**AMENDMENT NO. 1 MAY 2004
TO
IS 14787 : 2000 UNPLASTICIZED PVC PIPES (DUCTS)
AND FITTINGS FOR UNDERGROUND
TELECOMMUNICATIONS CABLE
INSTALLATION - —SPECIFICATION**

Amend No. 1 to IS 14787 : 2000

Fig. 6 DIMENSIONS OF TEST PIECE

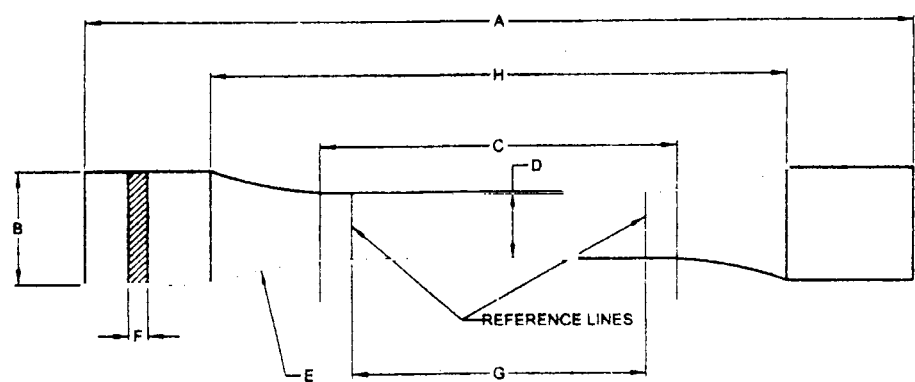
(Page 15, Annex N, clause N-2) — Insert the following Annex P after N-2:

The test specimen shall be prepared as per the dimensions given in Fig. 6.

All dimensions are in millimetres.

Overall length, <i>A</i>	150.0 Minimum
Width at ends, <i>B</i>	20.0 ± 0.5
Length of narrow parallel portion, <i>C</i>	60.0 ± 0.5
Width of narrow parallel portion, <i>D</i>	10.0 ± 0.5
Radius, <i>E</i>	60.0 Minimum
Thickness, <i>F</i> Minimum	1.0
Maximum	10.0
Preferred	3.0
Distance between reference lines, <i>G</i>	50.0 ± 0.5
Initial distance between grips, <i>H</i>	115.0 ± 0.5
NOTE — In any one specimen, the thickness of the narrow parallel portion shall nowhere deviate by more than 2 percent from the mean.
